# Supplemental Rebuttal Evidence of Mr T Wall

Project No: ITB12212  
Project Title: Land East of Downend Road, Portchester  
Title: Supplemental RPoE  
Ref: ITB12212-067b  
Date: 28 July 2021

**Image 3.1 – Extract of Image 5.3 of FBC Strategic Transport Assessment**

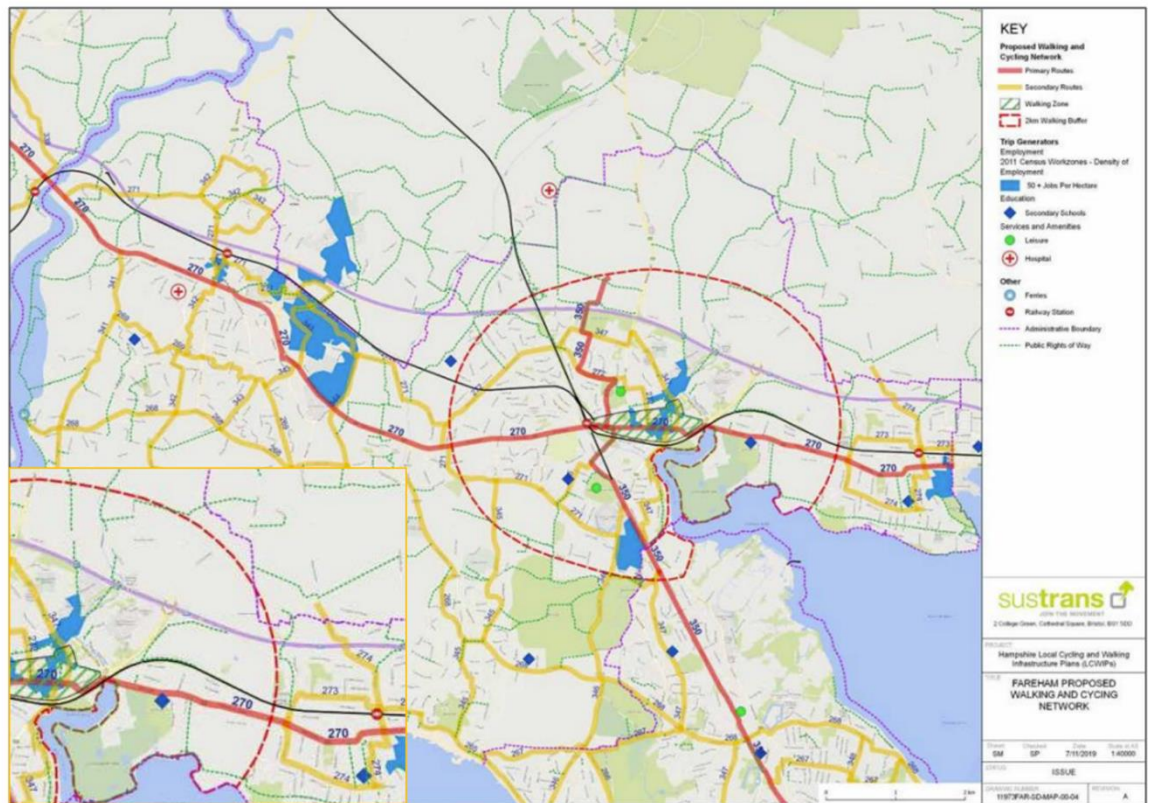
- FBC is preparing a Local Walking and Cycling Infrastructure Plan (LWCIP). In its Local Plan Strategic Transport Assessment (2020) it presents draft improvement measures, but no measures are proposed for Downend Road. In the absence of improvements to the cycling infrastructure on Downend Road, estimates of a doubling existing cycling use are unlikely;
